FSN781 00490

URGENT - Field Safety Notice Medical Device Correction

Ingenia Elition S, Ingenia Elition X

Unintended table movement after pressing 'stop-button'

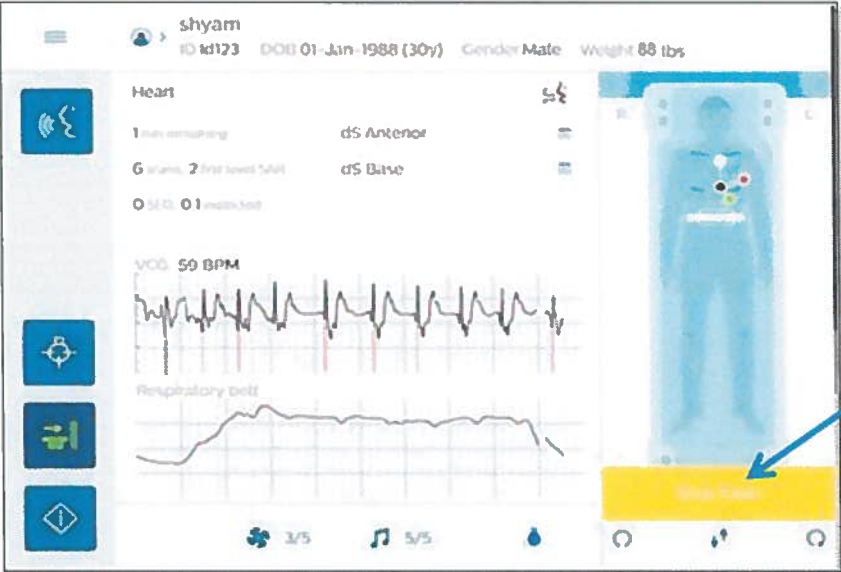
<p>AFFECTED PRODUCTS</p>	<p>Ingenia Elition S (781357), Ingenia Elition X (781358) MR systems</p>
<p>PROBLEM DESCRIPTION</p>	<p>Philips has become aware of a potential hazardous situation with the VitalScreen 'Stop Table' software button on the Affected Products (the yellow button on the right bottom corner as shown with the arrow below).</p> <p>During automatic tabletop movement, pressing and holding the 'Stop Table' button may lead to an unexpected restart of the table movement.</p>  <p>The issue does not occur when the Emergency Table Stop button or the tumble switch is used.</p> <p>Only a combination of the following factors may lead to unexpected table movement:</p> <ol style="list-style-type: none"> 1. User presses and holds the VitalScreen TTS button to initiate automatic tabletop movement (without the use of the tumble switch) and patient is moved into the bore. 2. Patient is taken (partly) out of the bore (example use cases: to inspect the patient or administer contrast) 3. To move the patient out, the VitalScreen TTS button is used again to initiate the second automatic tabletop movement 4. The user wants to stop the table movement 5. The user presses the VitalScreen 'Stop Table' button to stop the table movement. <p>The issue does not occur when the travel-to-scanplane (TTS) button on the VitalScreen is used for the first time during an examination (bullet 1 in the preceding list).</p> <p>The issue was found during an internal assessment at a Philips Test facility, and no person was injured. The issue is not reported by customers.</p> <p>In addition the FCO solves following issues:</p> <ul style="list-style-type: none"> - Software issues reported via customer feedback cases or internally reported issues. - The IfU and Technical Documentation (TD) were updated, amongst others, to be compliant with IEC60601-1-2 4th Edition (EMC).

<p>HAZARD INVOLVED</p>	<p>Mechanical entrapment of the patient between the tabletop and the system cover.</p>

HOW TO IDENTIFY AFFECTED PRODUCTS	Ingenia Elition S (781357) and Ingenia Elition X (781358) MR systems, with software R5.5.0.0
ACTION TO BE TAKEN BY CUSTOMER / USER	<p>The user must follow the Instructions for Use to verify that no part of the patient's body, hair, clothing, cables or infusion lines can get trapped or injured by any part of the equipment. Additionally, the VitalScreen shows positioning guidance regarding arm supports and padding.</p> <p>The user should avoid the use of the yellow 'Stop Table' button on the VitalScreen. The user must always use the tumble switch or physical 'Emergency Table Stop' button for cases which require the table movement to stop.</p>
ACTIONS PLANNED BY PHILIPS	<p>Via FCO78100490 Service Pack 1 for R5.5.0 will be rolled out to the affected systems. With this Service Pack the 'Stop Table' software button on the VitalScreen will be removed.</p> <p>The additional items mentioned in the problem description are implemented.</p>
